LOS CEDROS/HARVARD TRACT
PRELIMINARY OVERALL AREA DEVELOPMENT PLAN

Re: Los Cedros / Harvard Tract

POADP # 715

The City Staff Development Review Committee has reviewed Los Cedros/ Harvard Tract Subdivision Preliminary Overall Area Development Plan. Please note that your plan was not accepted, based on the following:

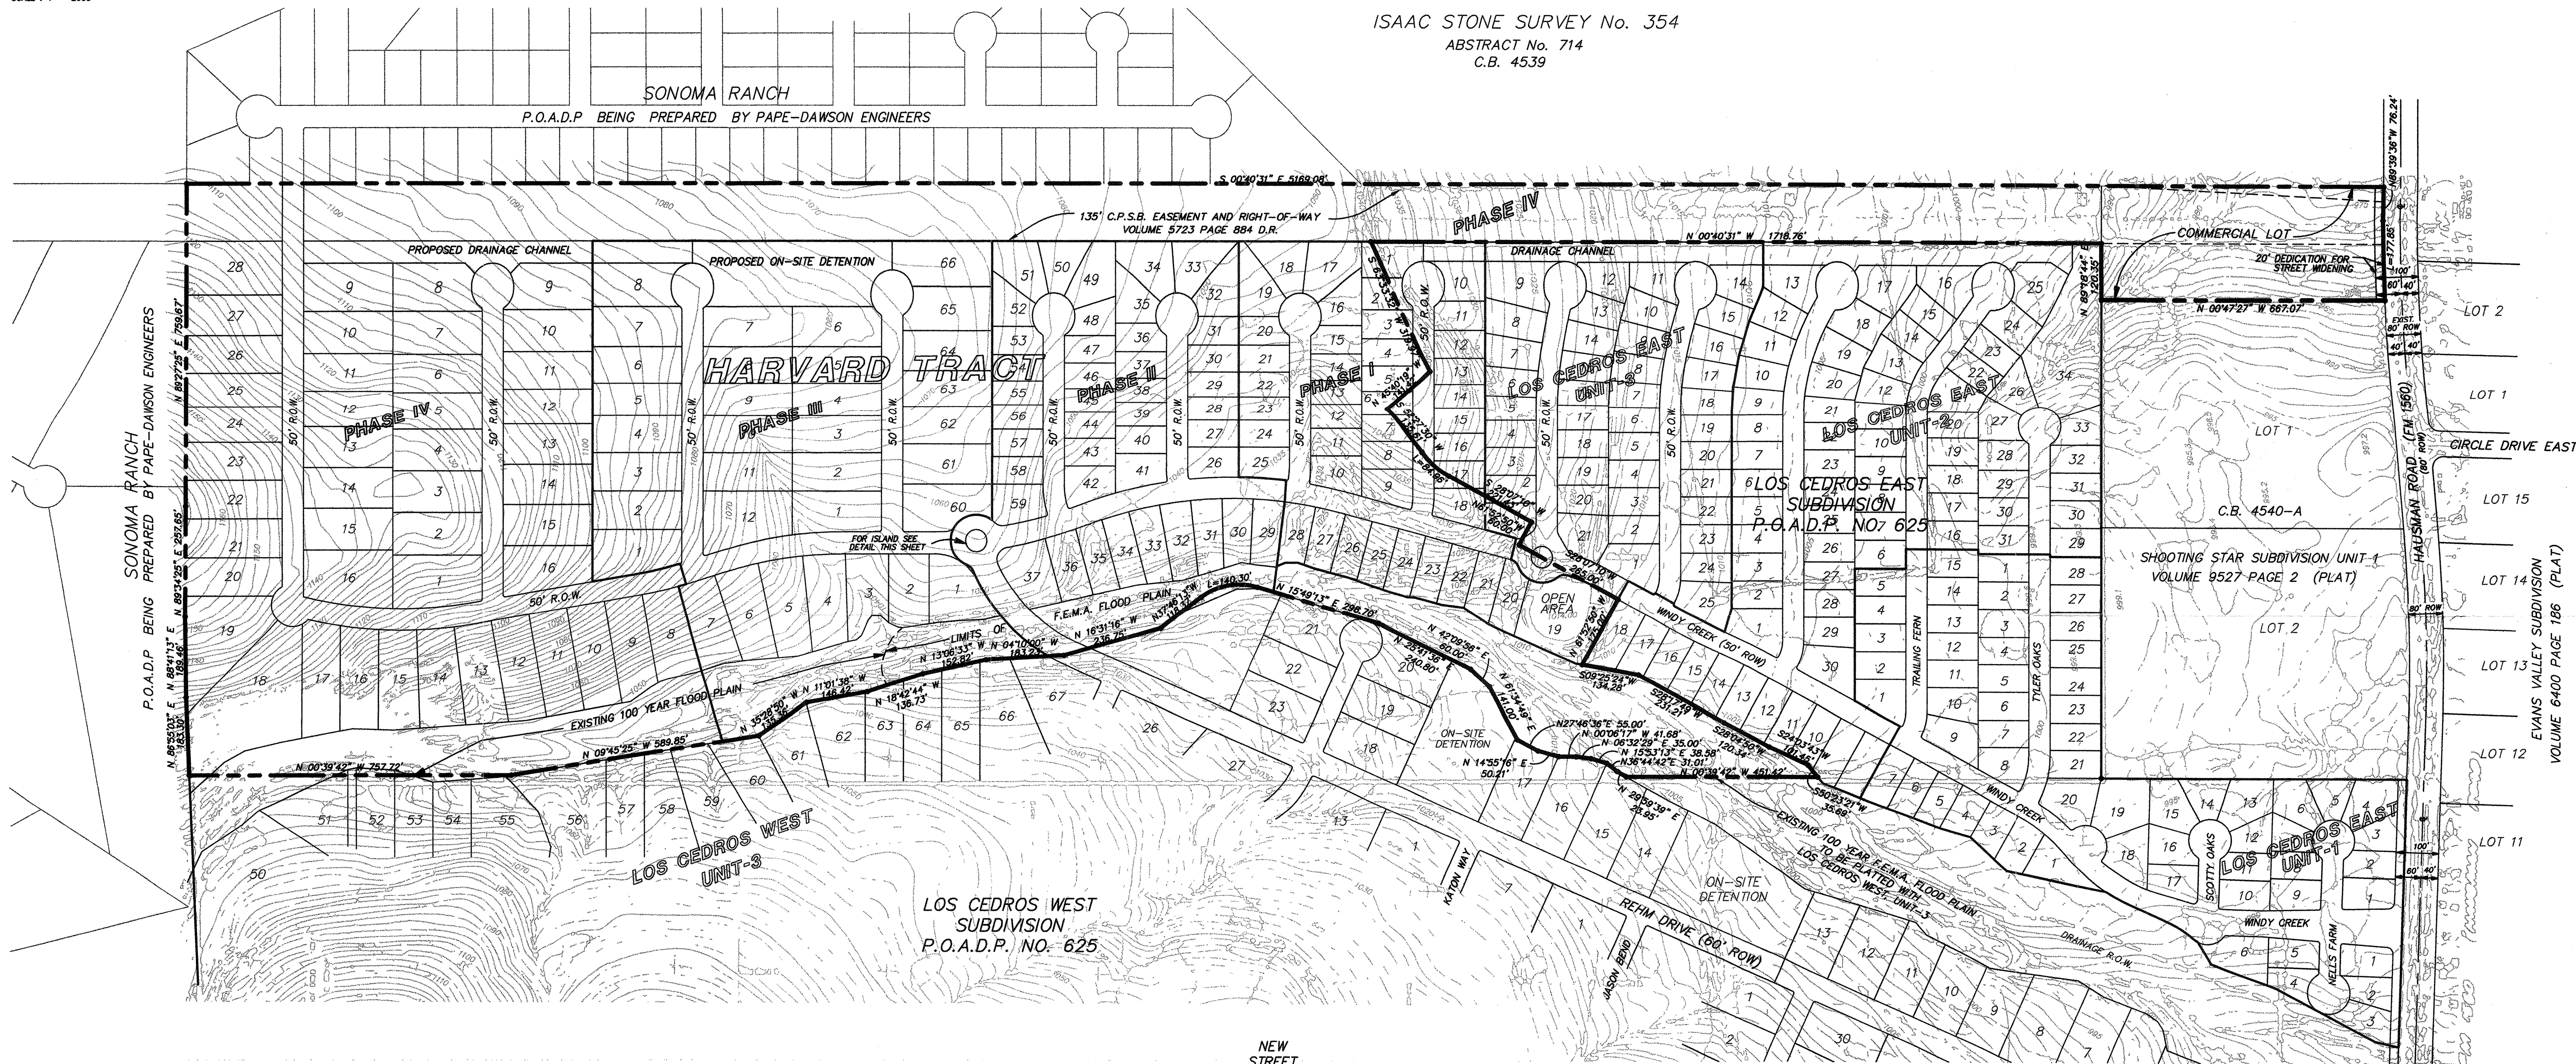
- (a) Annotate perimeter property lines.
- (b) Location Map is missing.
- (c) Your project does not indicate phase development.
- (d) Digital file is missing.
- (e) Coordinate with Sonoma Ranch (Pape-Dawson Eng./ Mr. Al Chua) for connectivity to the north.
- (f) Contour lines are not labeled.
- (g) Ownership of adjacent properties is missing.
- (h) Hausman Road right-of-way width is not annotated and the F.M. designation is missing.
- (i) Tx-Dot is requiring 20' feet of dedication along F.M. 1560 (Hausman Rd.)

Location Map. Indicate if phased
development, City Limits statement, show in
relation to Major Thoroughfares, ~~show~~
~~along ~~corrections~~ ~~planning~~~~

Comments: HAUSMAN RD IS ON THE MTP REQUIRING A
MIN OF 80' ROW. PROPOSE POADP ADDRESS THOROUGHFARE

Comments: HAUSMAN ROAD IS ON THE MTP REQUIRING
A MIN. OF 86' ROW. PROPOSE POADP DOES NOT
ADDRESS THOROUGHFARE. PROPOSE POADP REQUIRES A
LOCATION MAP.

Coordinate tree preservation
maintain this as a flood plain in a
natural state and provide pedestrian access is
recommended

05/08/01 REVISED PER CSA COMMENTS.
09/26/01 REVISED PER CSA COMMENTS.

PRELIMINARY DETAIL OF ISLAND
AT REHM DRIVE & WINDY CREEK
SCALE: 1" = 50'

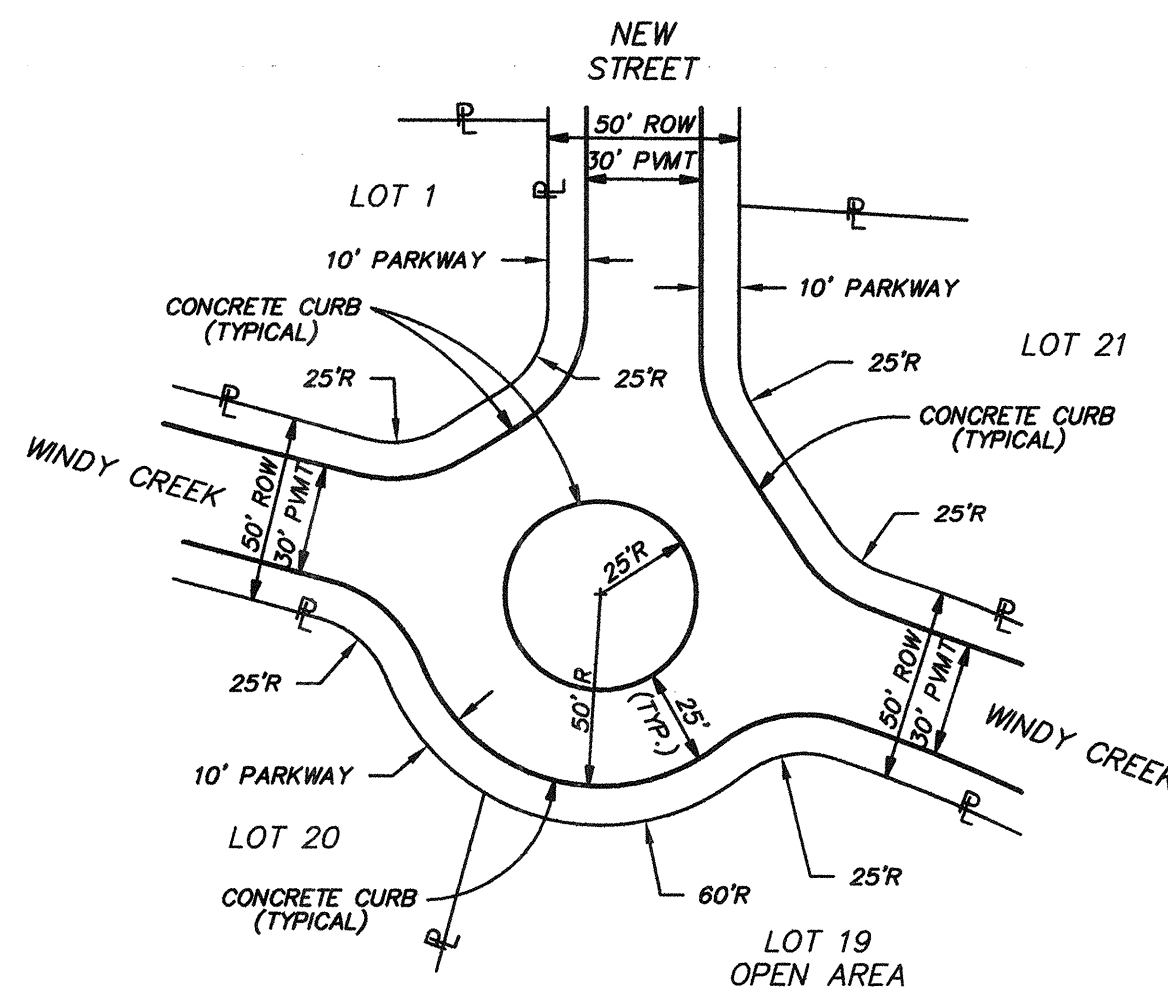
(j) Public Works is requiring a detail of the Island at the intersection of Rehm Dr. and Windy Creek.

Comments: provide detail for Traffic calming device
Coordinate with SOMMA Ranch POADP.
Dedication along Housman Rd. Provide
Location Map.
